Proposed Revisions to a Standard Plans Index

Index Number: 649-020

Sheet Number (s): 1, 4 of 6

Index Title: STEEL CCTV POLE

LAST REVISION	11/01/22	DESCRIPTION:	11/01/23	 FY 2023-24 STANDARD PLANS	STEEL CCTV POLE	INDEX 649-020	SHEET 1 of 6
---------------	----------	--------------	----------	--	-----------------	------------------	-----------------

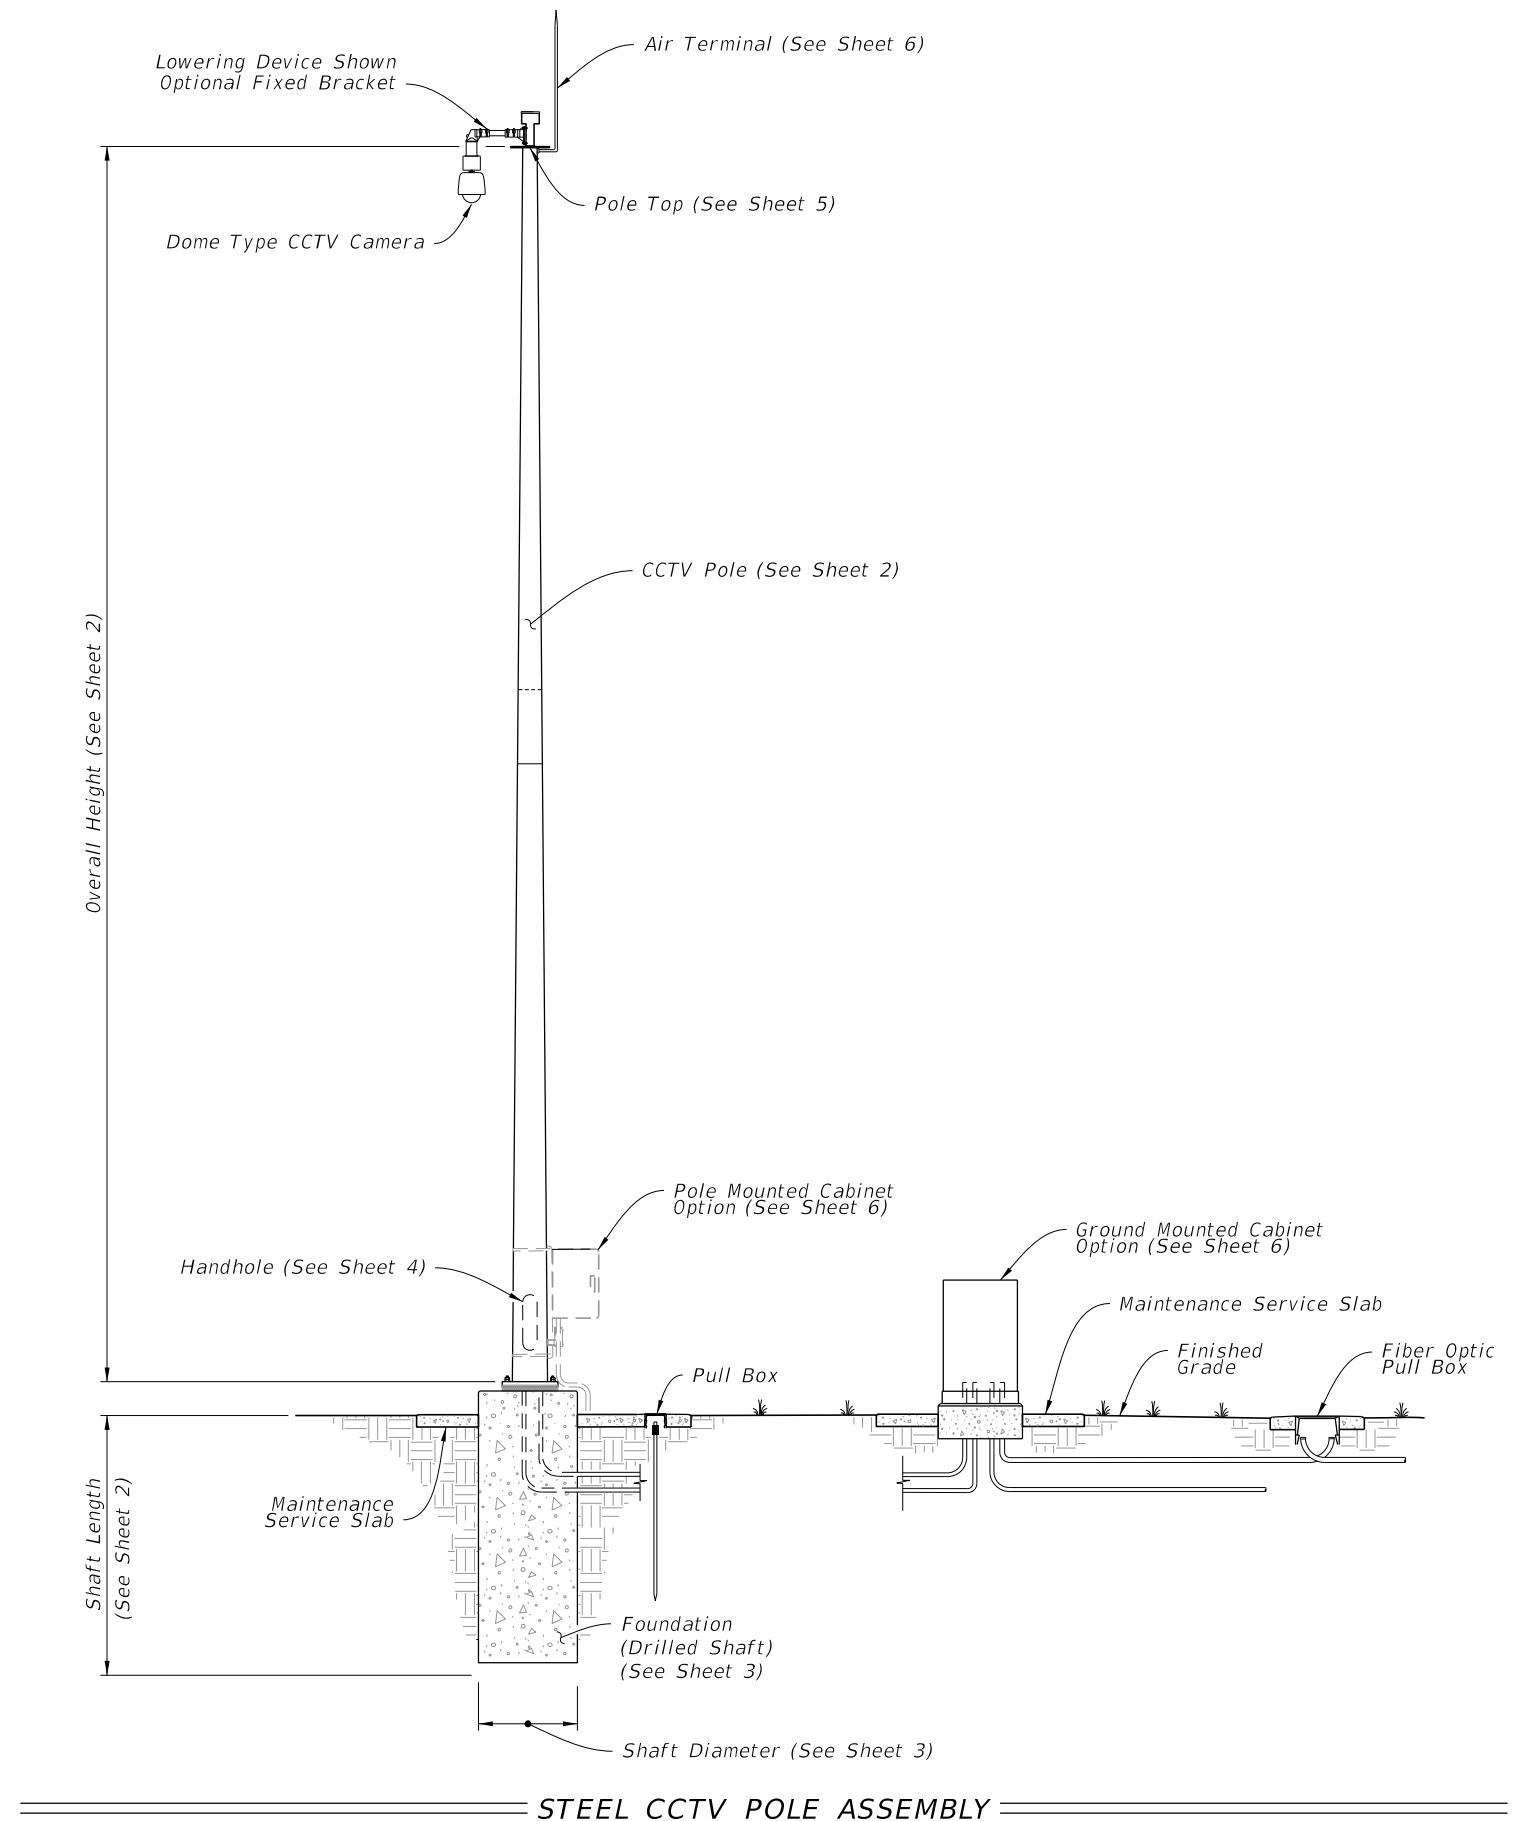
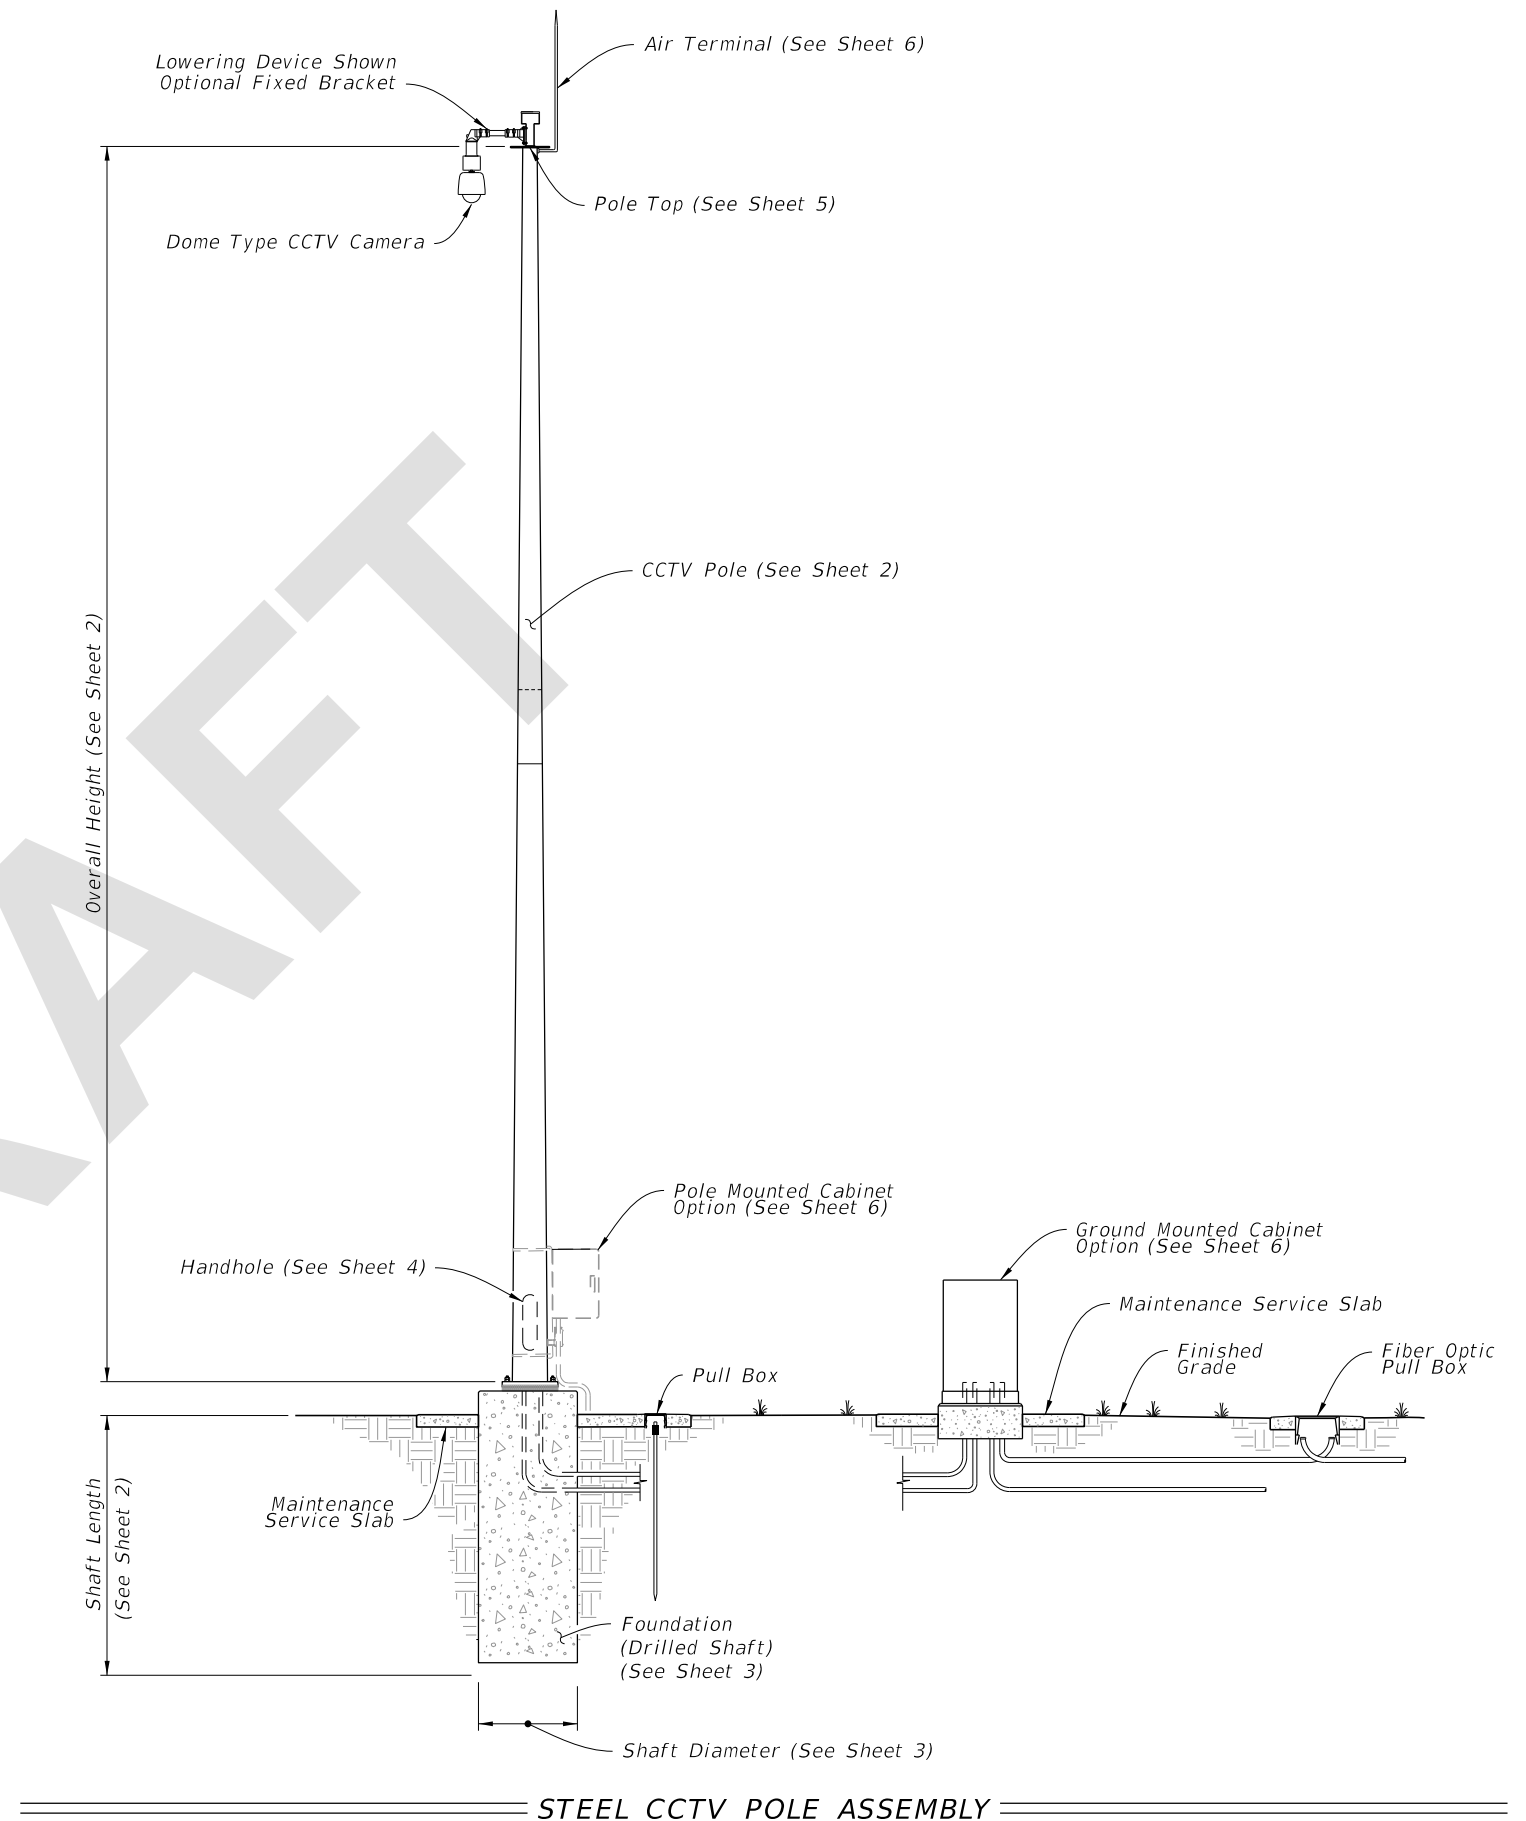
Sheet 1: Changed phrase from "full-penetration groove" to "complete joint penetration.

Sheet 1: Changing non-standard language to standard language consistent with AWS.

1. Use a ~~full-penetration groove weld~~ within 6 inches of the circumferential tube-to-plate connection and
 2. Use ~~full-penetration groove welds~~ on the female end section of telescopic (i.e., slip type) field splices for a minimum length of one and one-half times the inside diameter of the female section plus 6 inches.

complete joint penetration

1. Use a complete joint penetration weld within 6 inches of the circumferential tube-to-plate connection and
 2. Use complete joint penetration welds on the female end section of telescopic (i.e., slip type) field splices for a minimum length of one and one-half times the inside diameter of the female section plus 6 inches.

SHEET
4 of 6

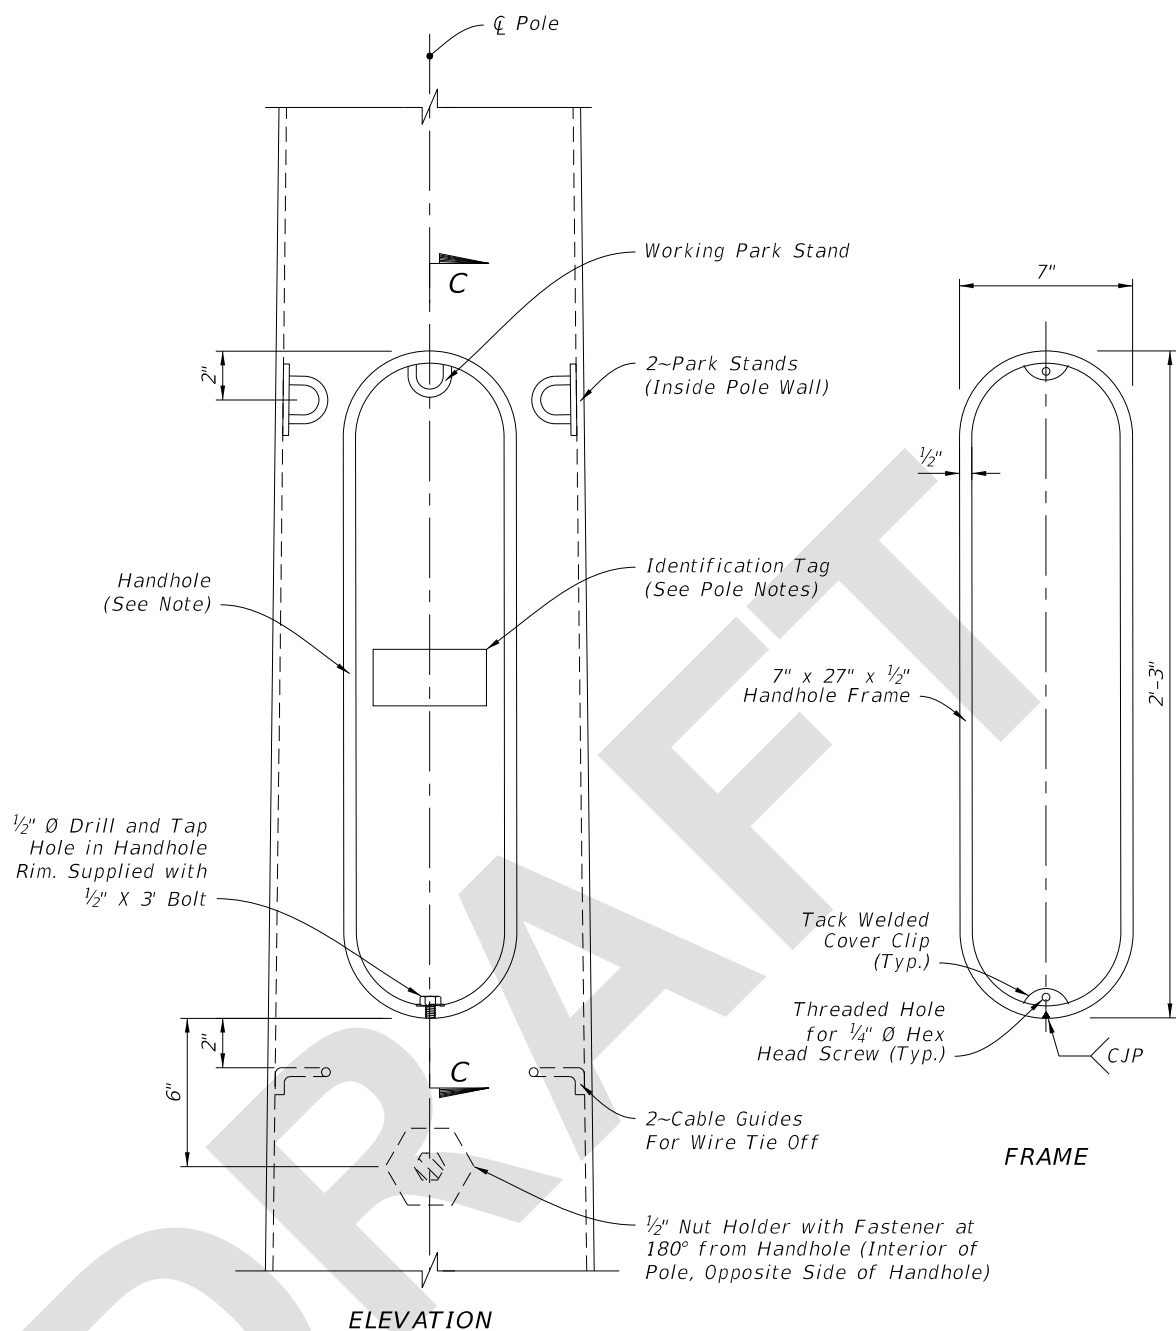
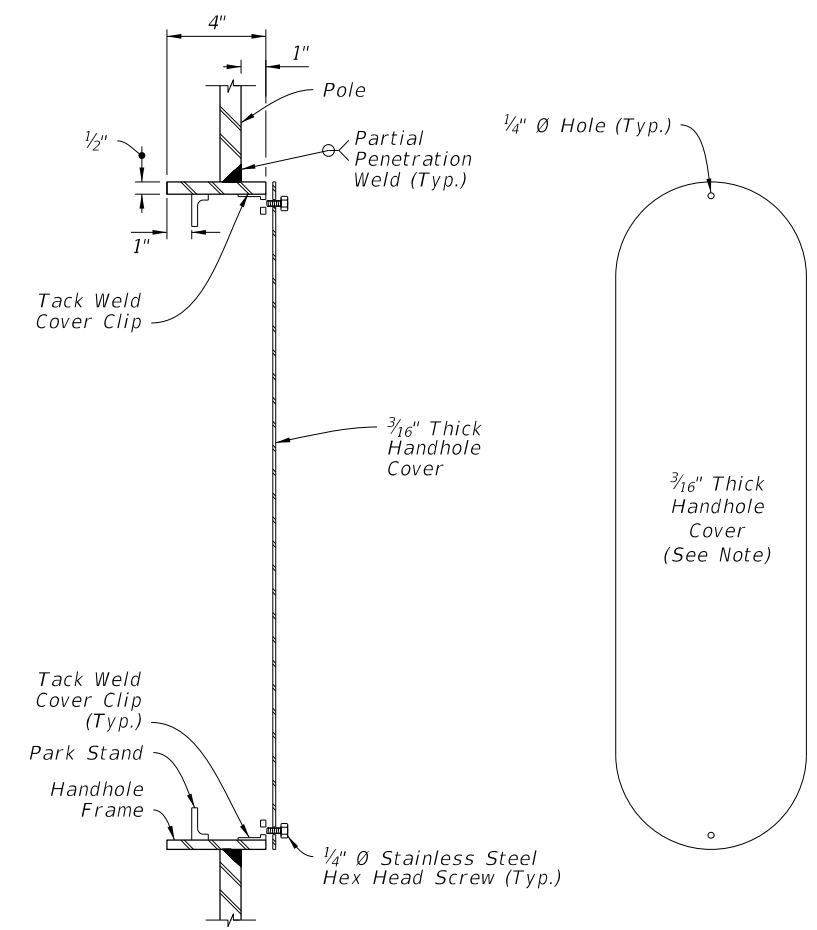
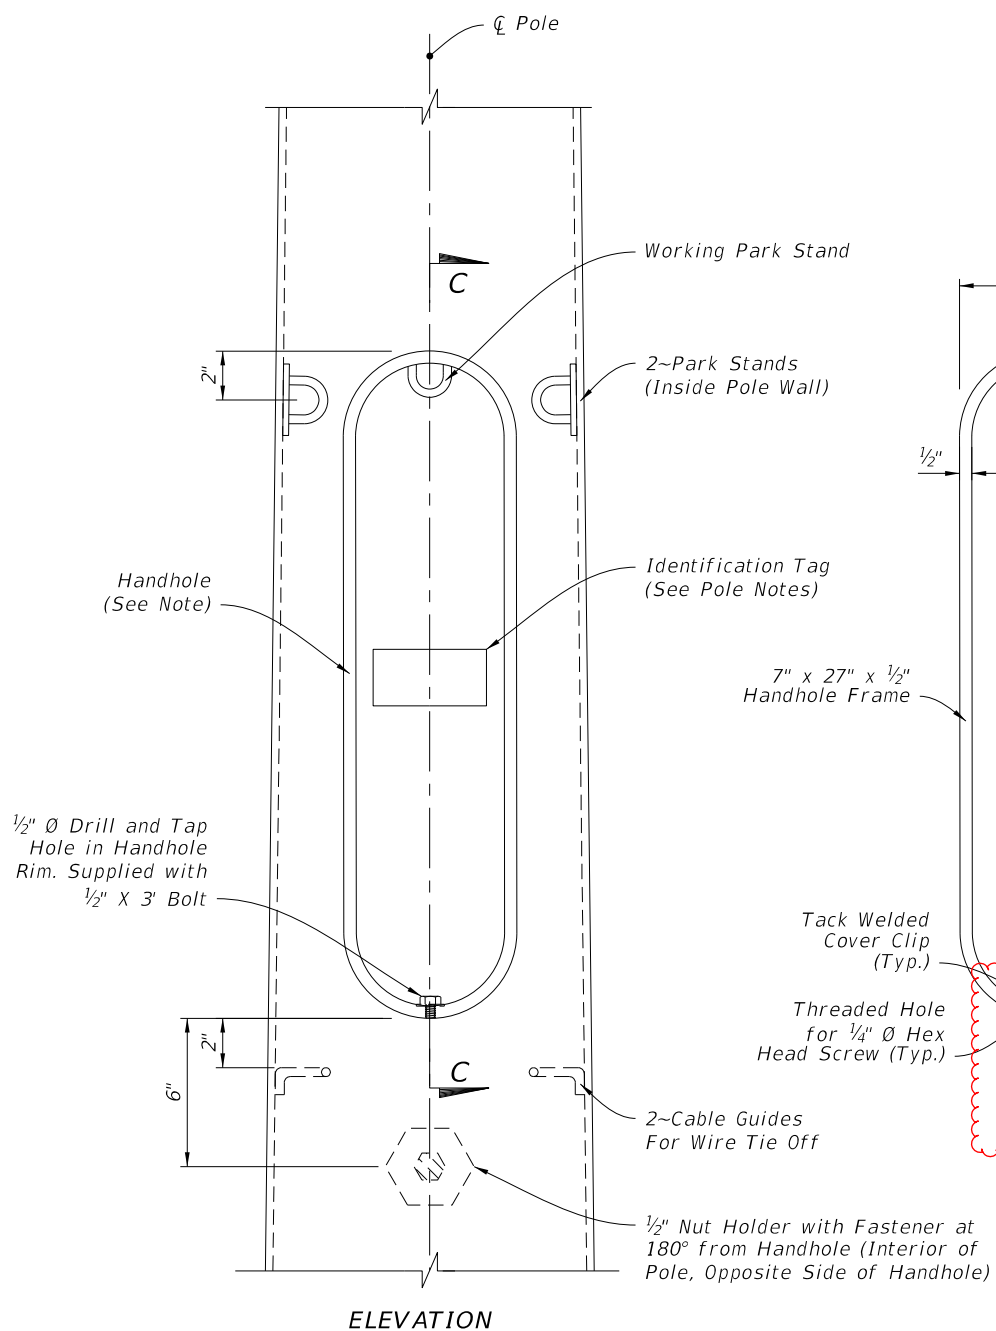
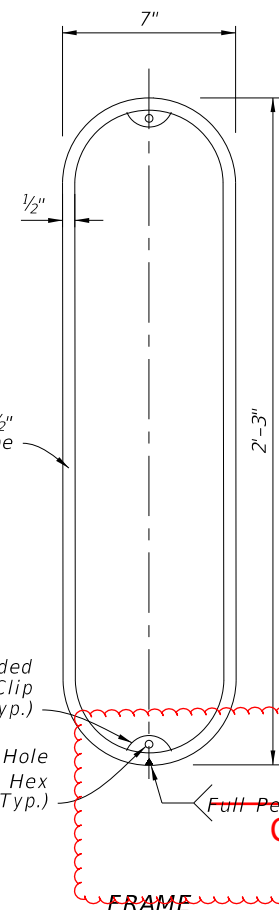
Sheet 4: Changed weld detail to say "CJP."

Sheet 4: Changing non-standard language to standard language consistent with AWS.
